VARIANCE APPLICATION SUMMARY

Project Summary – Northwest Bank

Meeting Date: August 27, 2025

Location: 191 Granville Street

FINAL DEVELOPMENT PLAN

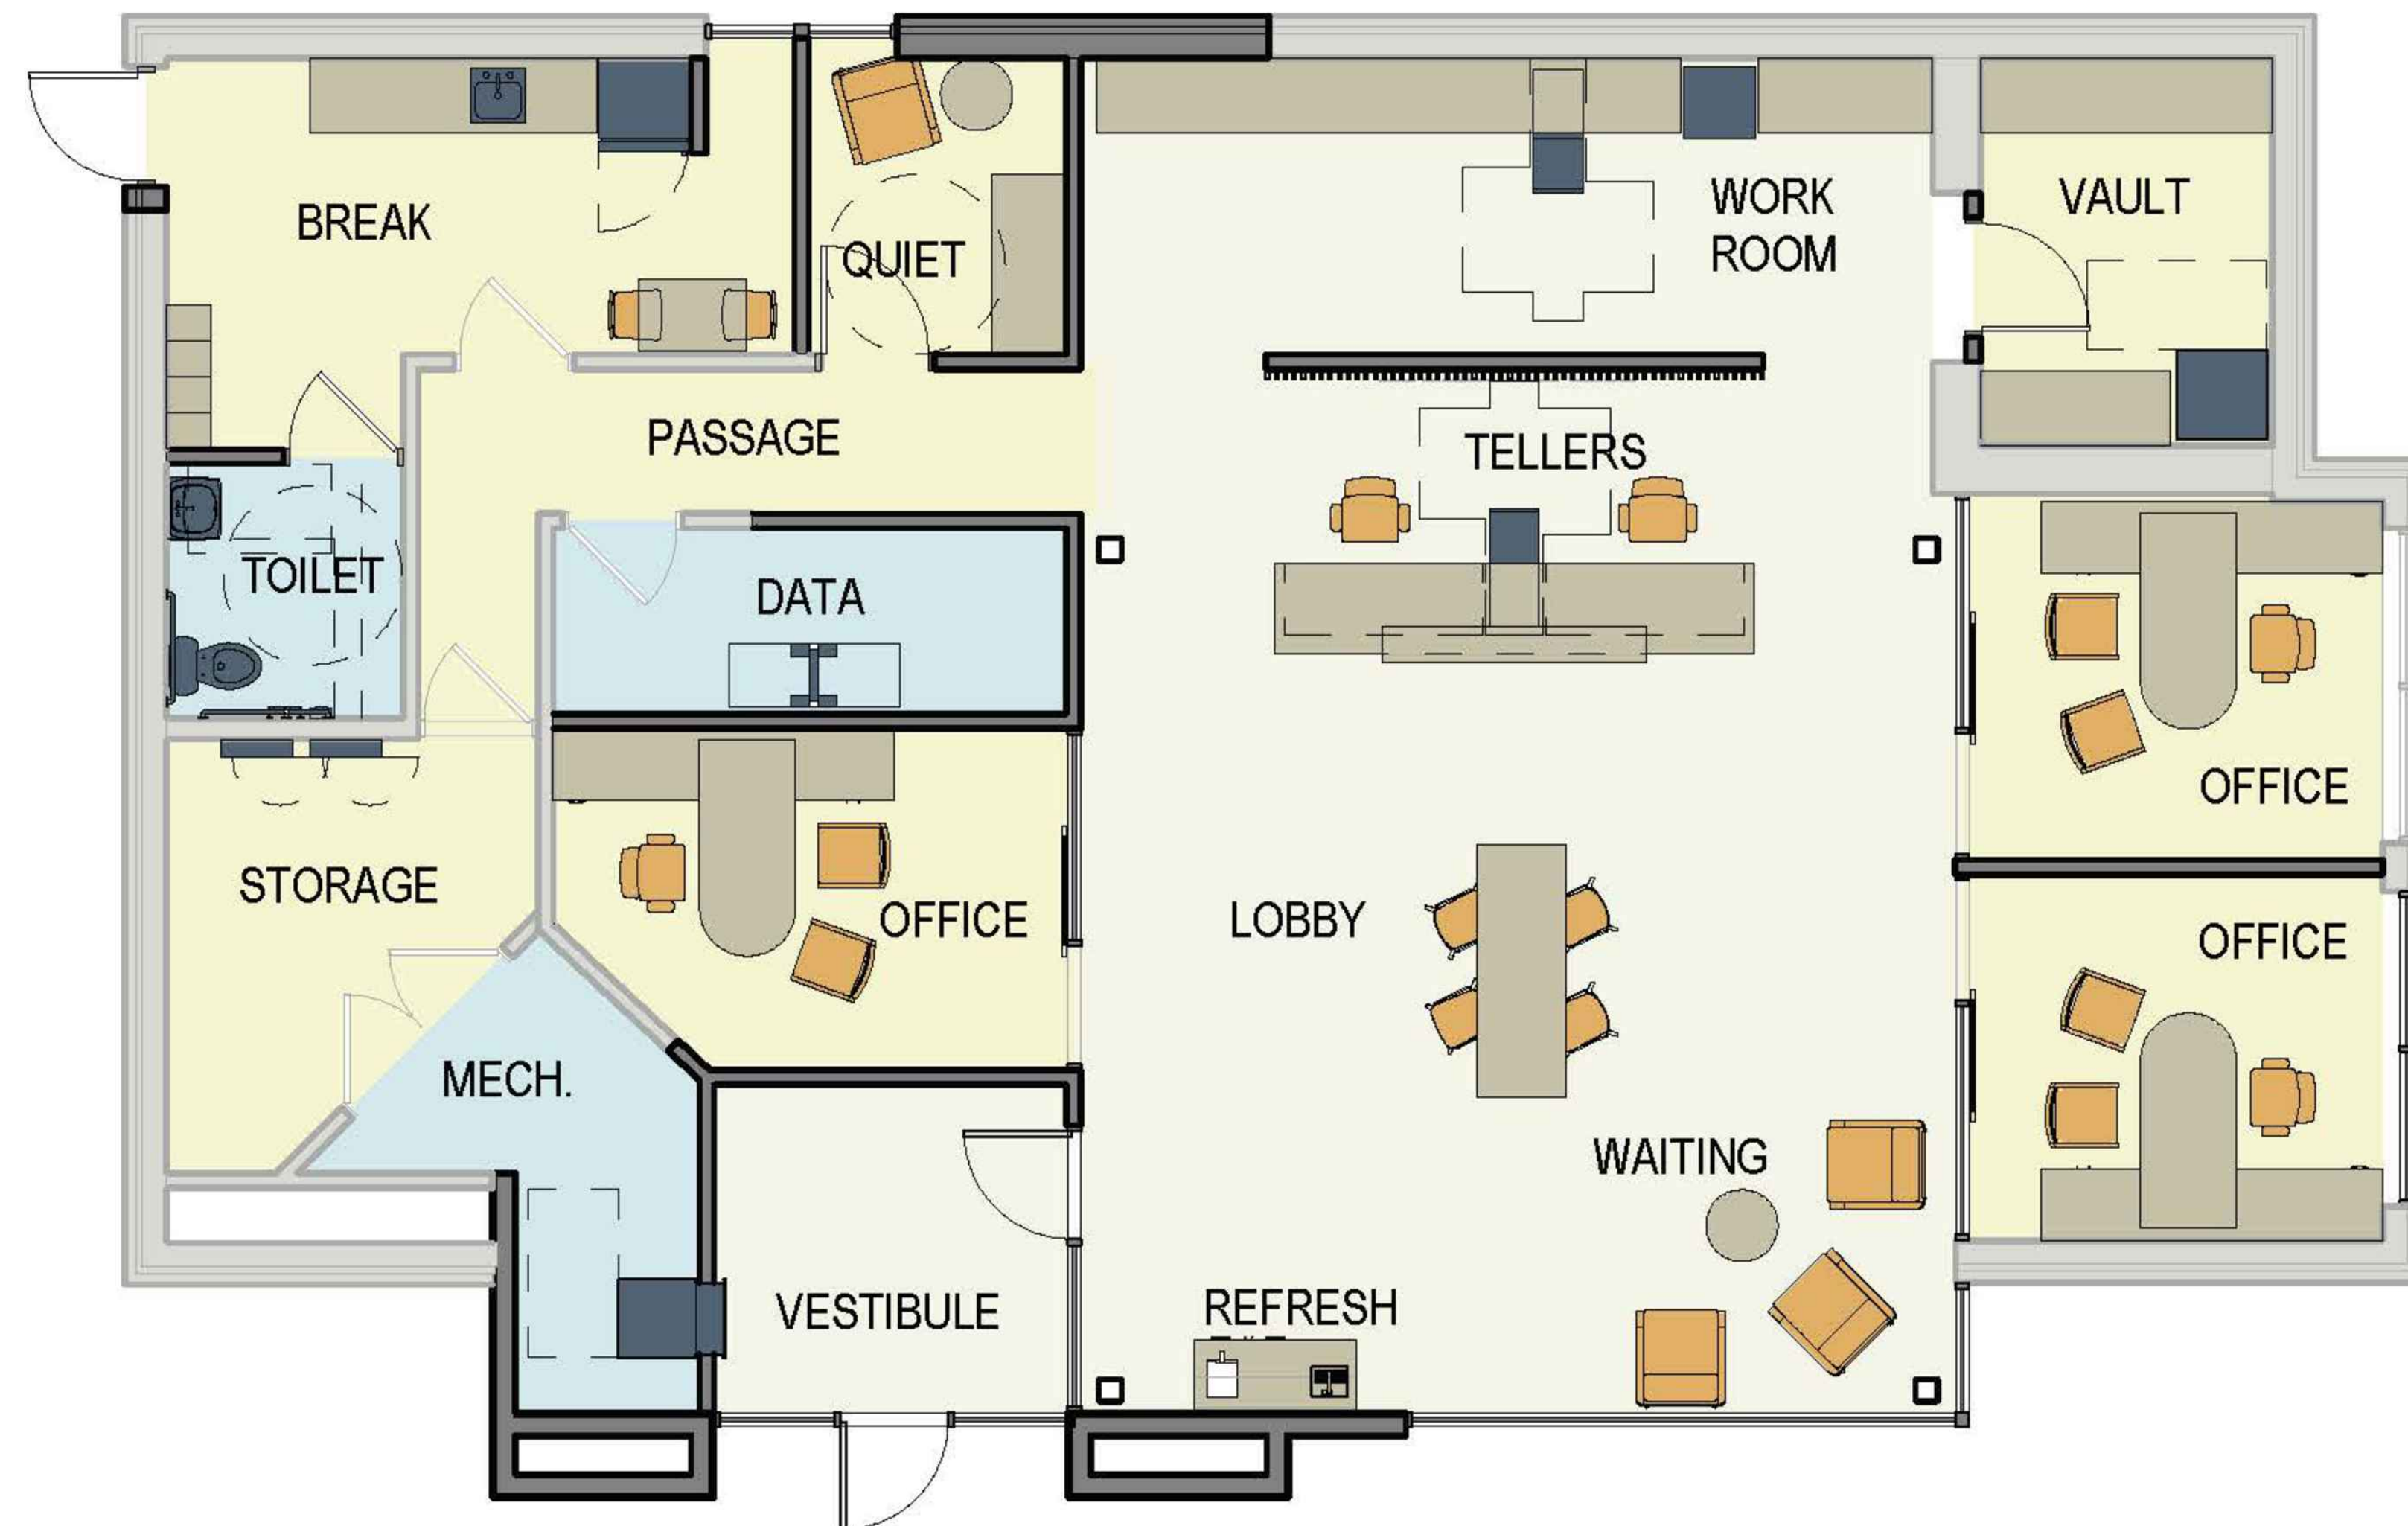
The current zoning code states that parking cannot extend past the front exterior wall. While the new parking lot will be further from the ROW than the current parking, there will still be 6 spaces past the front of the building. The applicant states that these spaces are necessary to meet the bank's needs, and they will be screened from the ROW by landscaping.

The parking area is also only 5 ft from the west property line, and the zoning code requires a parking setback of 10 ft from the side property lines. The existing parking lot has a 0 ft setback from the west property line, so the new parking lot more closely aligns with code requirements.

The parking area will more closely align with code requirements after the redesign. The parking lot is currently set back 0 ft from Granville St and 0 ft from the west property line. The proposed parking lot will be 10 ft from Granville St and 5 ft from the west property line. The applicant states that the bank needs the 6 parking spots to the front of the building to meet their parking needs.
